GREEN HARVEST SUBDIVISION

APPLICATION NUMBER 10 DATE December 1, 2005

DETAIL SITE PLAN

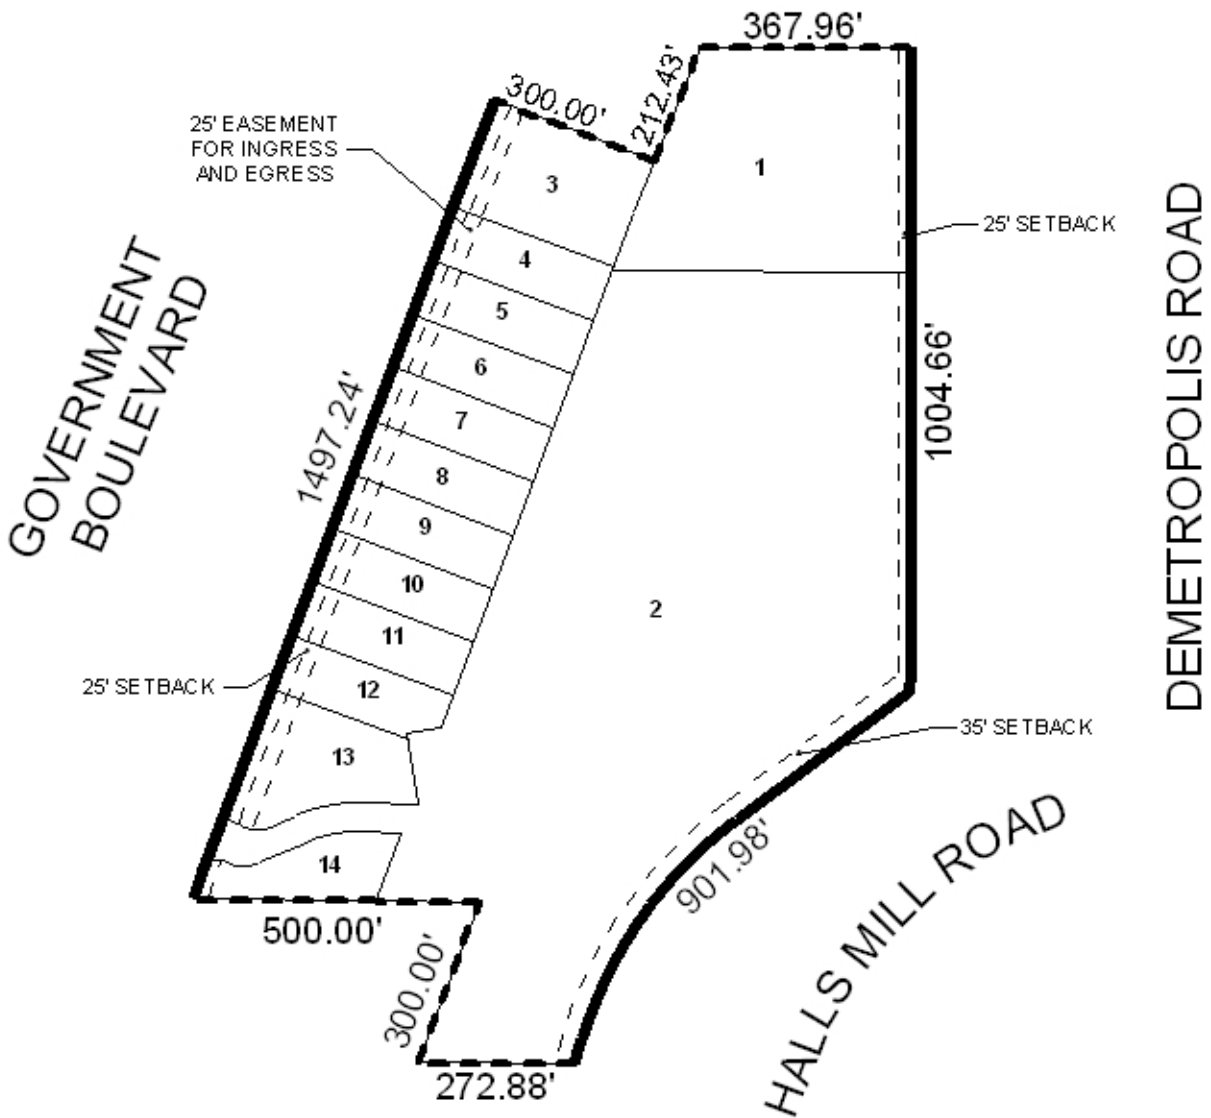
The purpose of this application is to create a 14-lot subdivision from multiple lots of record. Previously, an application was submitted for the Commission's November 3rd 2005 meeting. At that meeting, the Commission recommended a holdover until the December 1st meeting to allow the applicant time to submit a revised plat and a legal description reflecting the entire lots of record for the site plus any conditions associated with the approved 1994 rezoning. Subsequently, a new application was submitted, including the entirety of Lots 1 and 2. While the new application includes the entire property, it does not provide for a service road as required by the rezoning; but rather proposes a nonexclusive easement for an internal circulation drive. Therefore, the condition that Lots 3 through 14 cannot be recorded until the rezoning requirement for a service road along Government Boulevard has been addressed should be required. However, Lots 1 and 2 may be recorded prior to the removal of this condition.

The site fronts Government Boulevard, a planned major street and has an existing right-of-way in compliance with the Major Street Plan. Therefore, as a means of access management, the placement of a note on the final plat stating that the site be allowed a maximum of three curb cuts to Government Boulevard, with the location, size, and design to be approved by ALDOT and Traffic Engineering, should be required.

The plat meets the minimum requirements of the Subdivision Regulations and is recommended for Tentative Approval subject to the following conditions: 1) Lots 3 through 14 not be recorded until the rezoning requirement for a service road along Government Boulevard has been addressed; 2) the placement of a note on the final plat stating that the site be allowed a maximum of three curb cuts to Government Boulevard, with the location, size, and design to be approved by ALDOT and Traffic Engineering; 3) full compliance with Urban Forestry comments (*Preservation status granted for all 50" and larger trees. All work under the canopies is to be permitted and coordinated with Urban Forestry, removal to be permitted by Urban Forestry only in the case of disease or impending danger. Exact curb cut locations and location of the proposed street and internal circulation drive should also be coordinated with Urban Forestry to ensure that no trees 50" and larger are effected.*); and 4) full compliance with City Engineering comments (*Must comply with all stormwater and flood control ordinances. Any work performed in the right-of-way will require a right-of-way permit. Drainage easements and/or Hold Harmless agreements must be provided from any affected property owner for increased and/or concentrated stormwater discharge*).
